GLOBAL SAFETY FIELD INVESTIGATIONS  
DCS6806  
URGENT - DISTRIBUTE IMMEDIATELY

Subject: N232433290 - Service Update  
Engine Block Heater Cord Not Fully Seated

Models: 2024 Chevrolet Silverado 2500HD/3500HD  
2024 GMC Sierra 2500HD/3500HD  
Equipped with 8-Cylinder Duramax Diesel Engine (RPO L5P)

## N232433290 Engine Block Heater Cord Not Fully Seated

6557215

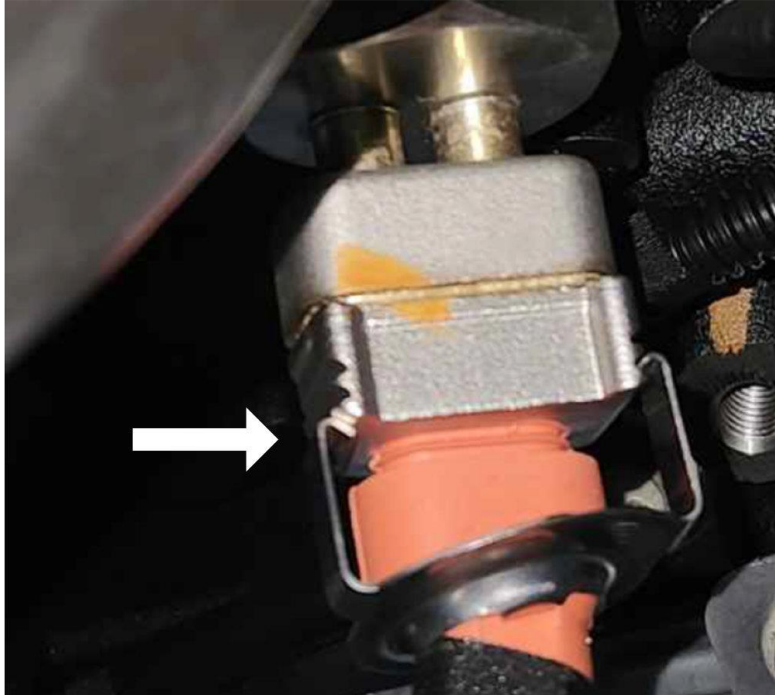
3. Locate the engine block heater through the opening in the wheel well liner.

6557216

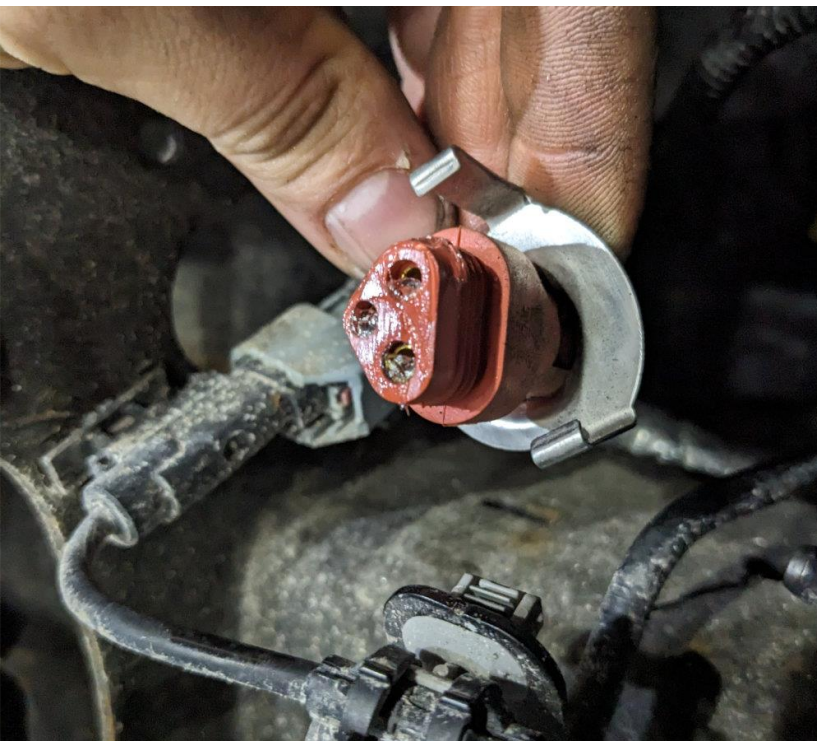
4. Inspect the engine block heater cord to be sure it is securely and evenly fastened into the engine block heater.
  - If the engine block heater is securely and evenly fastened (as step 3 shows), no further action is required. Proceed to step 8.

- If the engine block heater is NOT securely and evenly fastened (the metal ring will be at an angle relative to the block heater, and one or both sides may not be clipped in) proceed to step 5.
5. Remove the engine block heater cord from the engine block heater by unclipping the metal fastening ring around the cable.
